Access Compliance Report

Public Rights-of-Way

(Curb Ramps)

Intersection ID: 32027	Main Street: COLONIAL_REA_CT	Cross Street: STONECROFT_PARK_DR	Location: NW
ADA ID: C8217EEFFD62	Ramp Type: PerpDiag	Initial Pass/Fail: Fail	Overall Compliance: No
Severity Score: 42.5			
Codes/Mitigation Info/Possible Solution		Field Measurements/Component Compliance

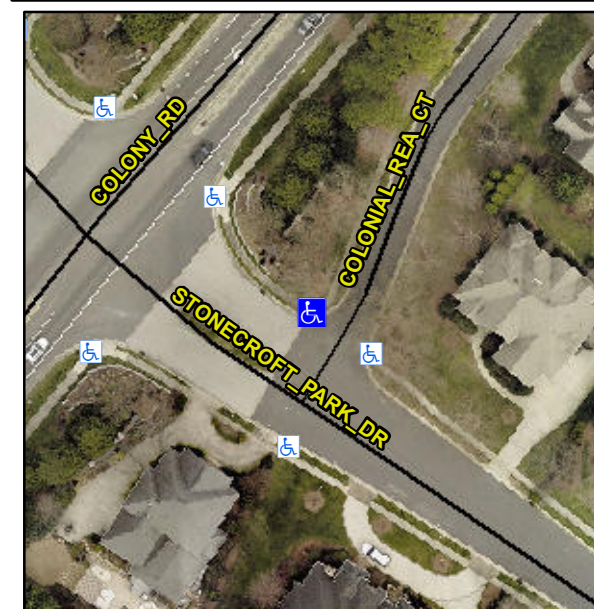
Not Found, R304.5.1, R304.5.3

Compliance	Description	Data	Compliance	Description	Data
N/A	Ramp Length (in)	72.0	Yes	Ramp Slope (%)	6.8
No	Ramp Width (in)	32.0	No	Ramp XSlope (%)	10.4
N/A	Flare Type LT	N/A	N/A	Flare Type RT	N/A
N/A	Flare Slope LT (%)	N/A	N/A	Flare Slope RT (%)	N/A
N/A	Flare Traversable LT?	N/A	N/A	Flare Traversable RT?	N/A
N/A	Landing Length (in)	N/A	N/A	DWS Provided?	N/A
N/A	Landing Width (in)	N/A	N/A	DWS Contrast?	N/A
N/A	Landing Slope (%)	N/A	N/A	DWS Length (in)	N/A
N/A	Landing X Slope (%)	N/A	N/A	DWS Full Width?	N/A
N/A	Landing Curb? (Y/N)	N/A	N/A	DWS Offset (in)	N/A
N/A	Shared Landing?	N/A			
N/A	Gutter Ponding?	N/A	N/A	Gutter Slope (%)	N/A
N/A	Gutter Lip Ht (in)	N/A	N/A	Gutter X Slope (%)	N/A
N/A	Painted X Walk1?	No	N/A	Painted X Walk2?	No
	X Walk 1 Direction	To SE		X Walk 2 Direction	To SW
N/A	X Walk 1 Width (in)	N/A	N/A	X Walk 2 Width (in)	N/A
	X Walk 1 Slope (%)	0.3		X Walk 2 Slope (%)	5.7
	X Walk 1 X Slope (%)	6.0		X Walk 2 X Slope (%)	6.5

N/A	Ramp inside XWalk1?	N/A	N/A	Ramp inside XWalk2?	N/A
	Road Slope (%)	6.5	N/A	Clear Space?	N/A
	Road X Slope (%)	1.9	N/A	Clear Space to XWalk (in)	N/A
N/A	Any Obstructions?	N/A	N/A	Storm Grate/Utility Hazard?	N/A
	Obstruction Type			Storm Grate/Utility Type	
		N/A			N/A
			Yes	Surface Condition? (G/P)	Good

Remove & Replace Curb Ramp With Two New Directional Ramps or Equivalent.
